Building plan assessment application

Application number: 1650950
Property address: 83 Brixton Rd, Berala 2141
Lot details: Lot 17, Deposited Plan 635
Property Number: 3691566

18/05/2023

FURTHER ASSESSMENT

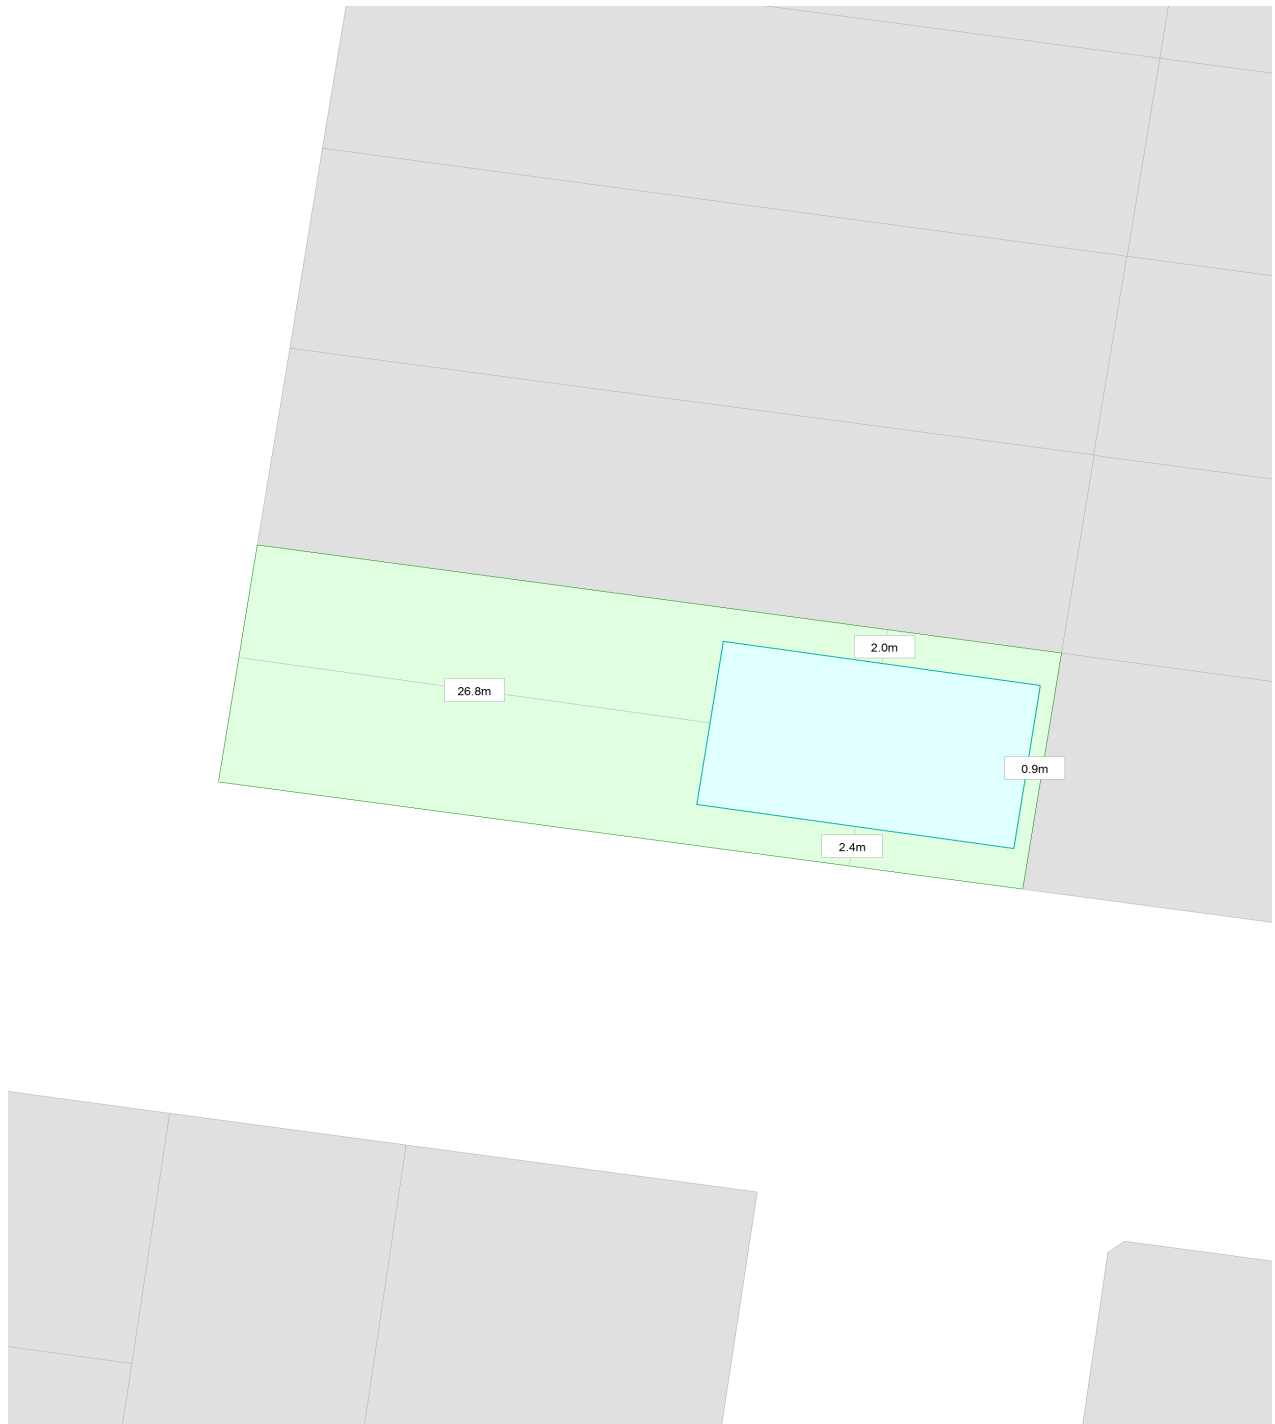
Structure(s) that may impact Sydney Water infrastructure		
Structure 1	New home	18.0 m x 10.0 m x 0.1 m

This structure may impact Sydney Water infrastructure.

Structure 1	New home	18.0 m x 10.0 m x 0.1 m
1. Main within load impact zone. Sewer Main; Asset Number: 3627638.		
2. Main within work site. Sewer Main; Asset Number: 3627634.		
3. Structure within load impact zone. Sewer Structure - Maintenance Hole; Asset Number: 1310285.

1. Engage a Water Servicing Coordinator to complete your assessment
A list of Water Servicing Coordinators is available on our website www.sydneywater.com.au and go to the plumbing, building and developing page for a list of water servicing coordinators.
2. Take this referral to the Water Servicing Coordinator so they can complete the application for you.
3. You will need to use the following Sydney Water reference number when you contact the Water Servicing Coordinator .
